**ALLSTAR PZL GLIDER Sp. z o.o.**  
ul. Cieszyńska 325  
43-300 Bielsko-Biała  
tel: +48 (0)33 8125021, fax: +48 (0)33 8123739  
e-mail: office@szd.com.pl  
Approval : EASA Nr AP 108

**SERVICE BULLETIN**  
**No BE-011/SZD-59/2009 „ACRO”**

**DESIGNATION-TYPE/MODEL:** SZD-59 „ACRO”

**CONCERNS:** Replacing of a fuselage frame part.

Fig.1.

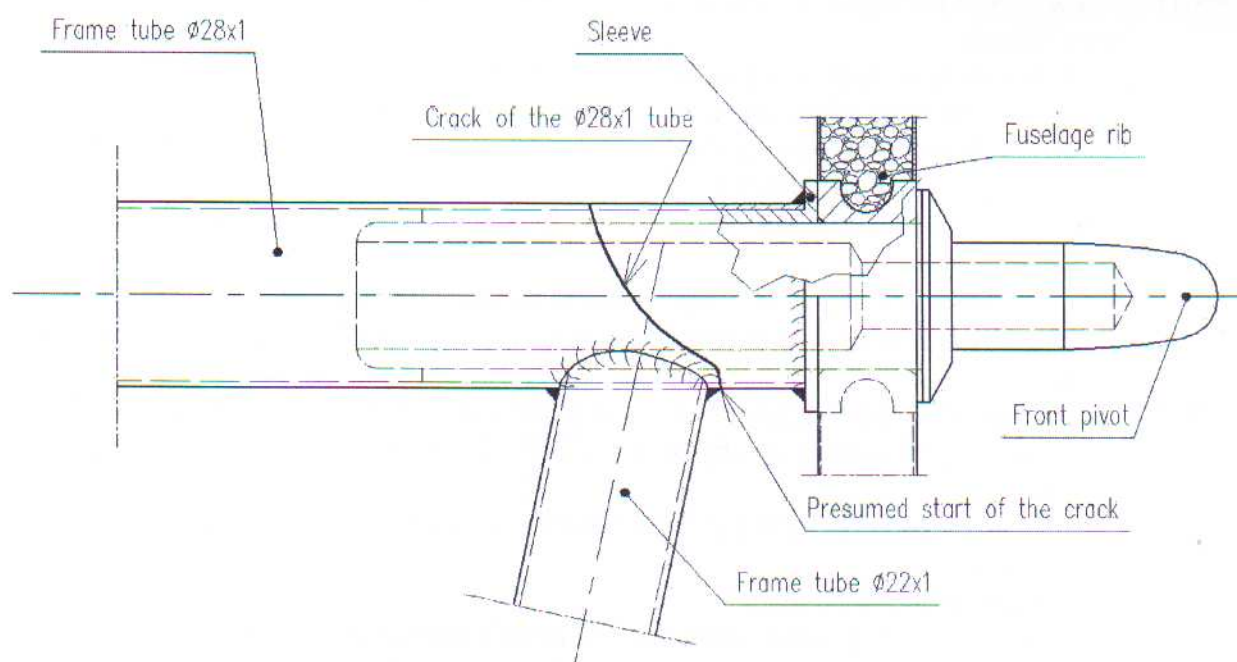
During the exploitation of gliders a fatigue crack of the left front welded joint of the fuselage frame had been detected. The crack is a result of presumed high stress level and intensive exploitation in aerobatics. Real stresses initiates the cracks which can, in extreme case, cover all the diameter of the outer tube (Fig.1.).

Fig.2.

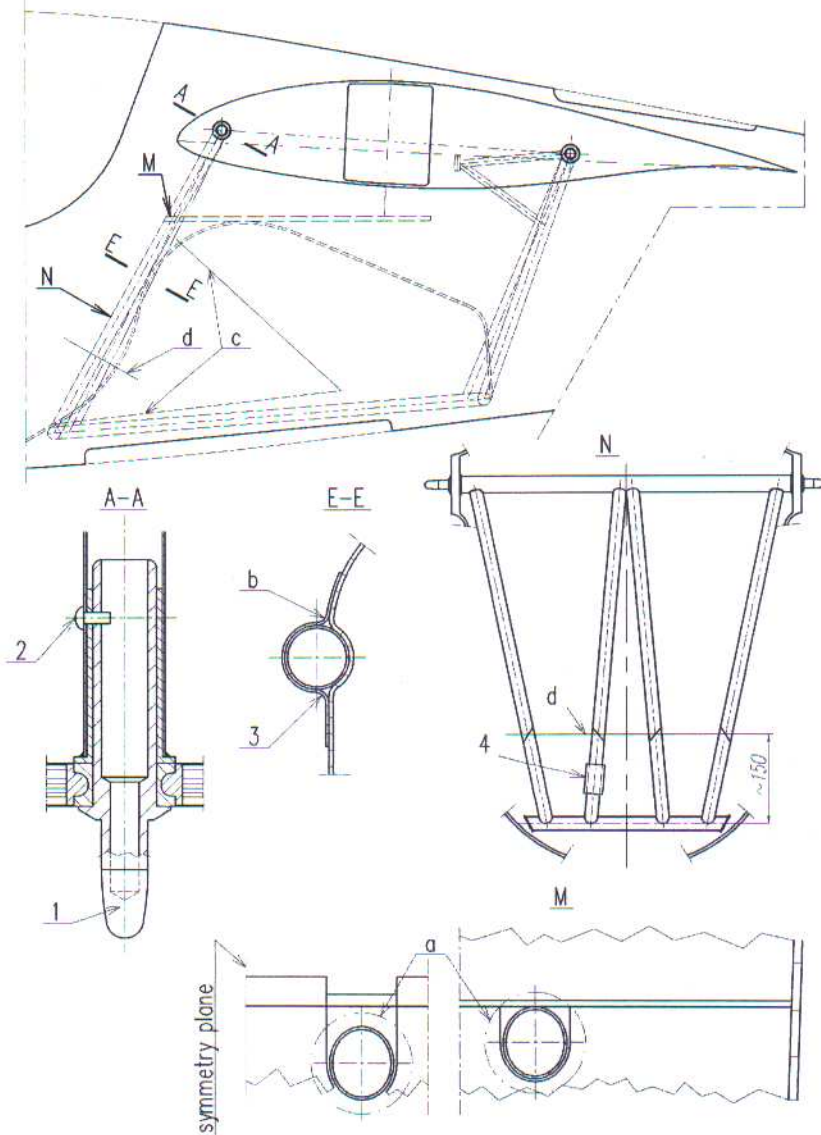
- 3.1. CG hook's control is to be disconnected.
- 3.2. Main wheel is to be dismantled.
- 3.3. Front landing gear leg is to be dismantled.
- 3.4. The composition from area (a) – Fig.2, detail M – is to be removed.

- 3.5. Straps (3) – made of 1x92110 fabric – are to be cut in the corners (b) of the landing gear box – Fig.2, section E-E.
- 3.6. For make welding easier, landing gear box is to be cut along (c) line – Fig.2.  
Cut off part is to be taken out.

- 3.7. The 4 diagonal tubes of the frame are to be cut at level (d) with angle  $\sim 45^\circ$  – Fig.2.
- 3.8. The rivets (2) – Fig.2, section A-A – are to be drilled from head side with  $\varnothing 4$ mm drill.

- 3.9. The pivots (1) – Fig.2 – are to be removed from the frame. The pivots are settled by H7/k5 fit, therefore adequate force is required to be used. In case of damage, the damaged pivot is to be replaced by a new one from the kit.

- 3.16. Holes  $\varnothing 3,9$ mm for rivets (2) – Fig.2 – are to be drilled. Inner surface of the tube is to be preserved by anti-corrosive fluid by rivet holes. Steel rivets  $\varnothing 4$ mm are to be driven into holes.

- 3.21. In the control table (4) – Fig.2. – a letter "R" is to be marked permanently, the control table is to be remounted by 2 AL blind rivets.

Fig.3.

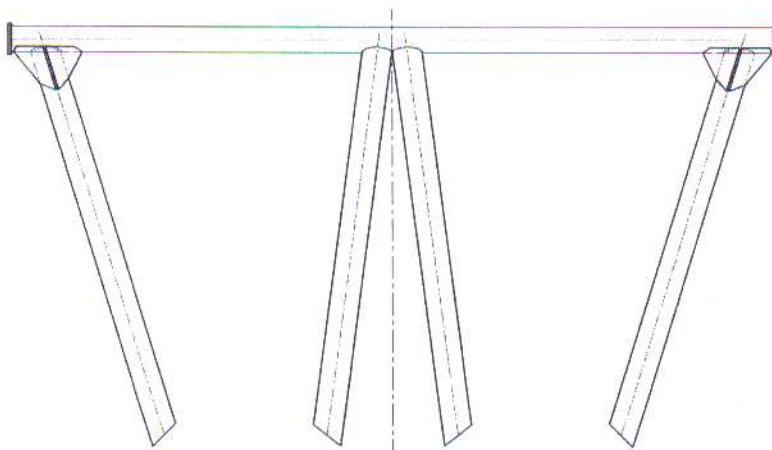
Part of the frame (Fig.3., according to sketch 590.12.00/BE-011) with aligning sleeves, one frame pivot and welding wire is being delivered by Allstar PZL Glider.
